Title		
Size: A	Number	Revision
Date: 6/08/2024		Sheet of
File: C:\Users\..\Power_Section.SchDoc		Drawn By:

Title		
Size: A	Number	Revision
Date: 6/08/2024	Sheet of	
File: C:\Users\..\Transmitter_Receiver_Section.SchDoc	Drawn By:

100V BOOST REGULATOR

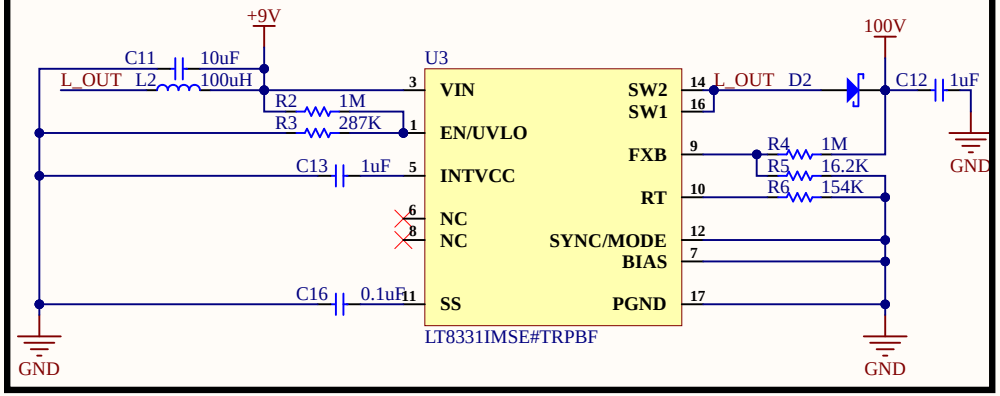
LT8331EMSE#TRPBF is out of stock from lcsc, may I used alternates [LT8331IMSE#TRPBF](stock = 105)
The Differnece between them is Operating juction temperature.

Connections in given schematic were different from reference schematic for R2 and C13.
Reference schematic from datasheet is followed for R2 and C13 connection

TRANSMITTER CIRCUIT

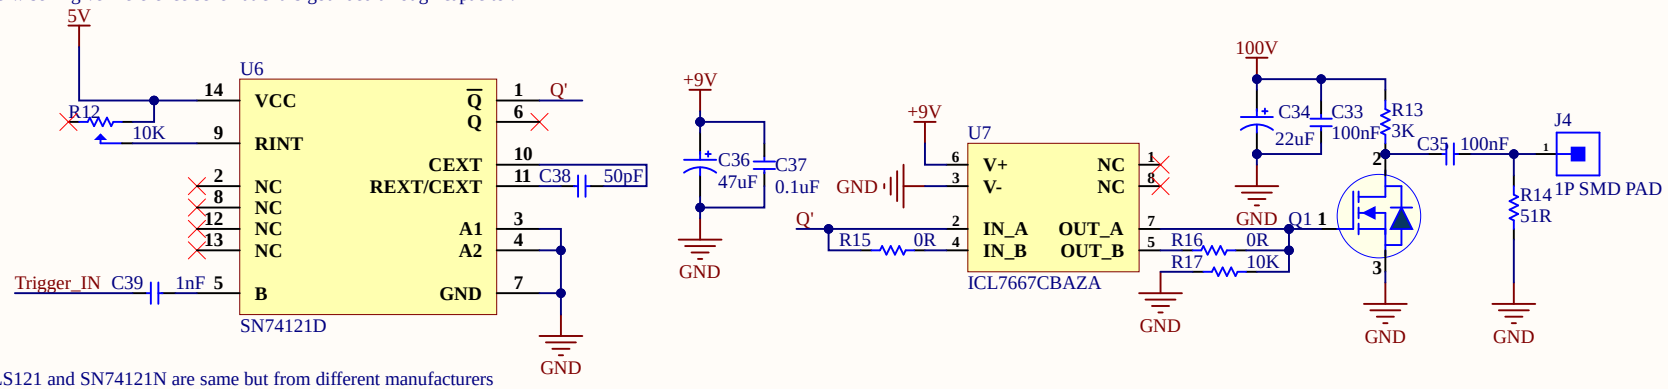
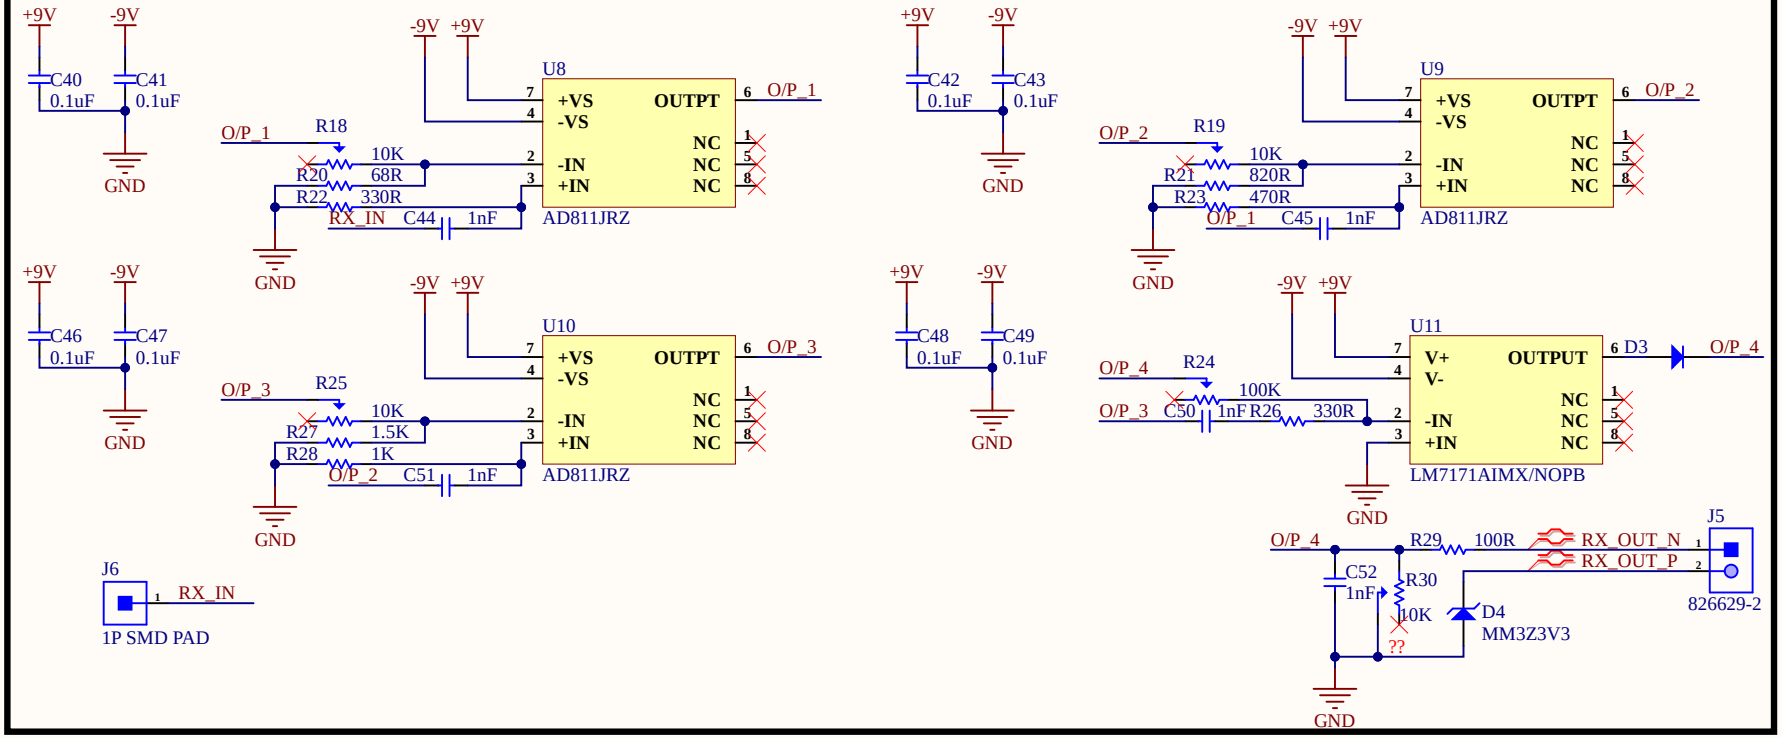
Trigger_IN through capacitor is given to input B,
otherwise in given reference schematic it is gounded through capacitor.

3kOhm (0.25W), 10kOhm (0.25W) and 50Ohm (1W) Required ratting mention in link

74LS121 and SN74121N are same but from different manufacturers
